**August 27, 2018**

**Re: Renewable Industry Response to Revised Draft Tier 1 Inventory Report by Exeter & BCS For RPS Study Group**

### Exhibit 1: PJM Tier 1 Supply Scenarios vs. Demand Under 50% MD RPS (2030)

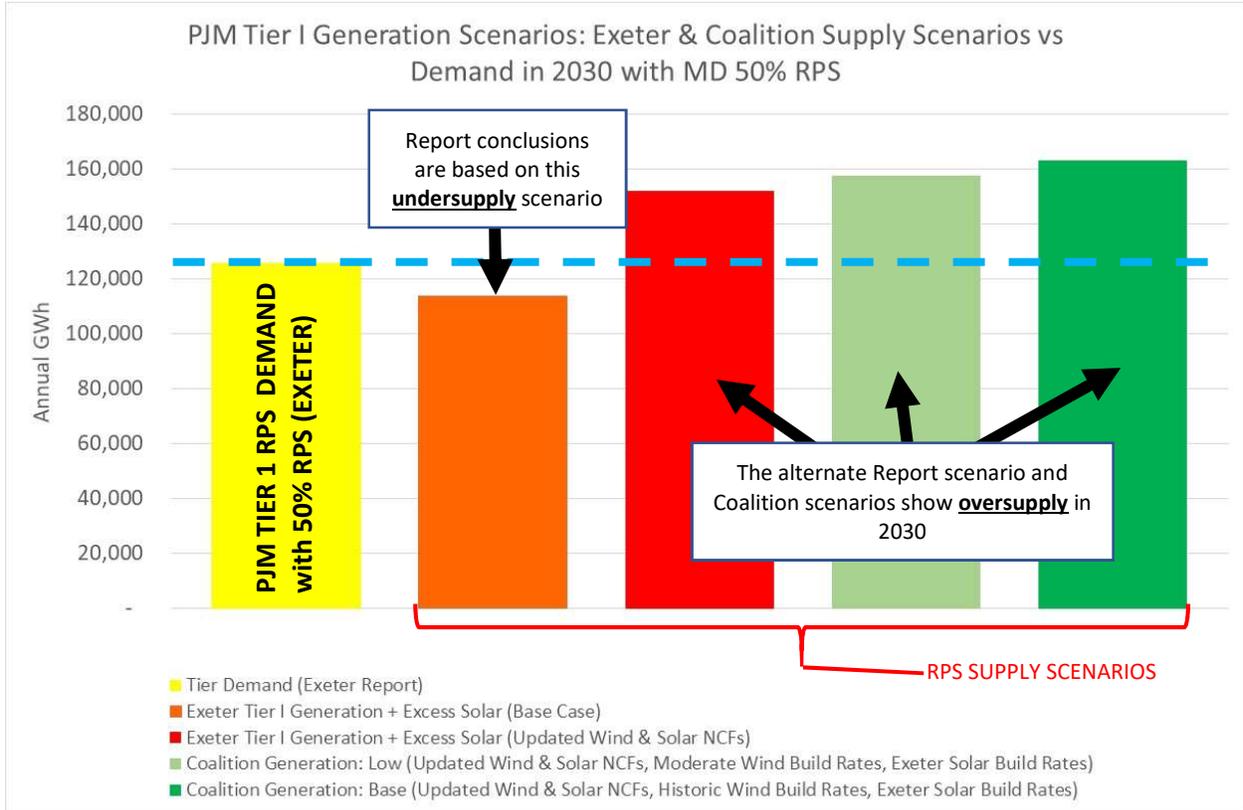
Exhibits 1 and 2 below highlight four scenarios of Tier 1 REC supply: two scenarios explored in the Report and two additional scenarios offered by the Coalition based on a more realistic set of assumptions. Three of the below four scenarios, including the Coalition scenarios and one of the two scenarios in the Report, forecast a Tier 1 REC market in balance through 2030 with periodic oversupply. The fourth scenario in the Report, used as the basis of the Report’s conclusions, data tables, and exhibits, is an outlier based on overly conservative assumptions that projects Tier 1 REC undersupply. The assumptions that drive the various scenarios are discussed below the two Exhibits.

In the above Exhibit 1, the yellow bar represents the Report's estimate of PJM Tier 1 Demand in 2030 and includes both the recent 50% NJ RPS expansion and an expansion of the Maryland RPS to 50% as contemplated in legislation proposed in the 2018 Maryland legislative session. The orange bar represents the conservative scenario that is the basis of the Report's conclusions. The red bar and green bars assume updated net capacity factors ("NCF") for wind and solar that are representative of today's technology and defensible via multiple credible third-party sources. The green bars also reflect increased annual wind addition rates, with the highest scenario on the right-hand side assuming the average historical wind addition rates from the past 10 years (725 MW/year). Exhibit 2 utilizes the same color scheme and shows annual Tier 1 supply projections in each scenario vs demand through 2030.
